INDIANA DEPARTMENT OF ENVIRONMENTAL MANAGEMENT

Source Name: Amazon Data Services Incorporated

Permit Level: TV New Source Construction (Minor PSD/EO)

Permit Number: 141-47750-00642

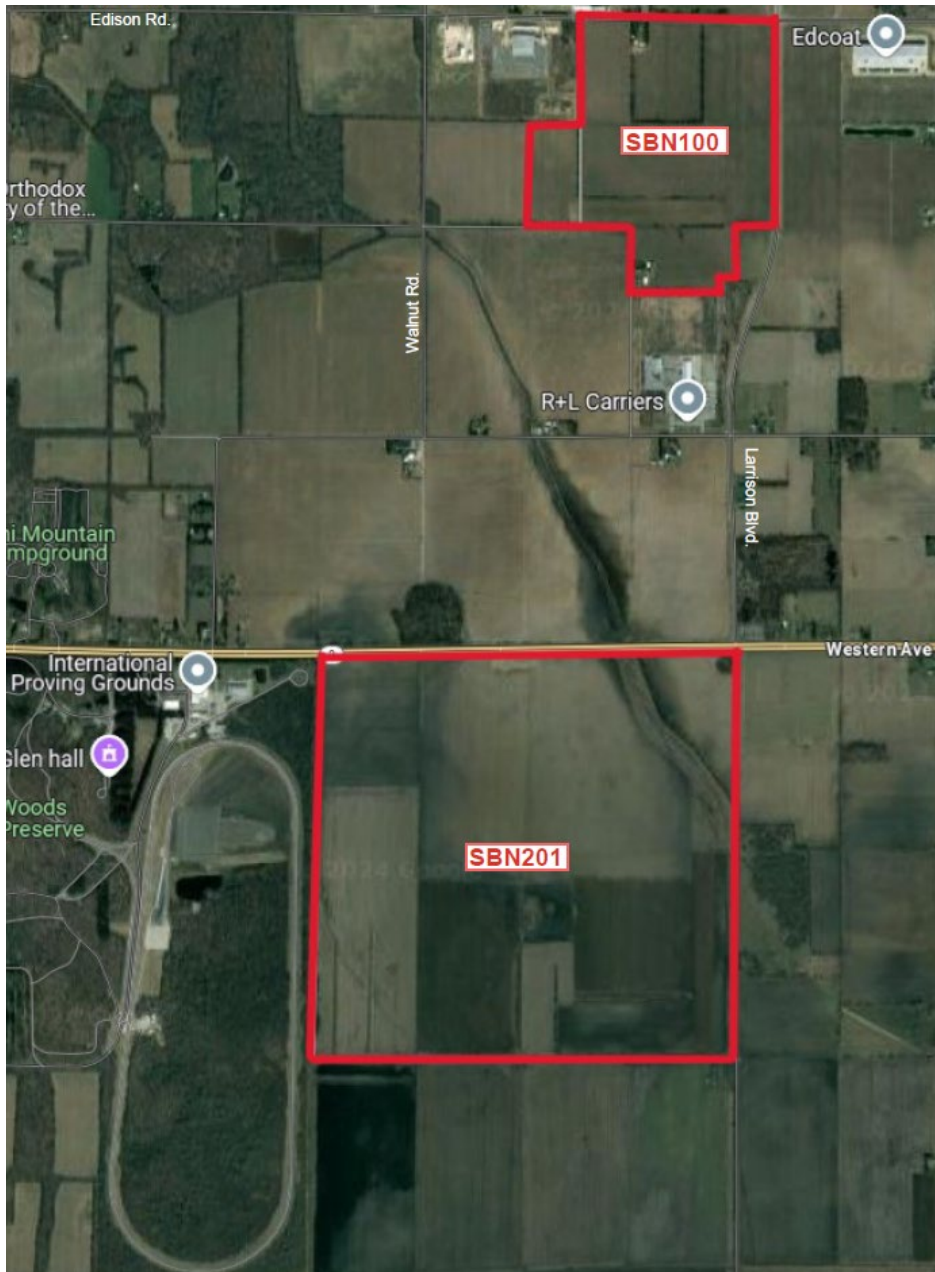
For additional guidance regarding the term "adjacent" in stationary source determinations, see the 11/26/2019 EPA memorandum entitled: "Interpreting 'Adjacent' for New Source Review and Title V Source Determinations in All Industries Other Than Oil and Gas."

IDEM Response to General Statement 1 – Source Determination

IDEM, OAQ, has documented the detailed source determination made in the TSD that was provided during public comment period. IDEM, OAQ, used the following resources to make the analysis for the source determination and make the conclusion that these are 2 separate sources:
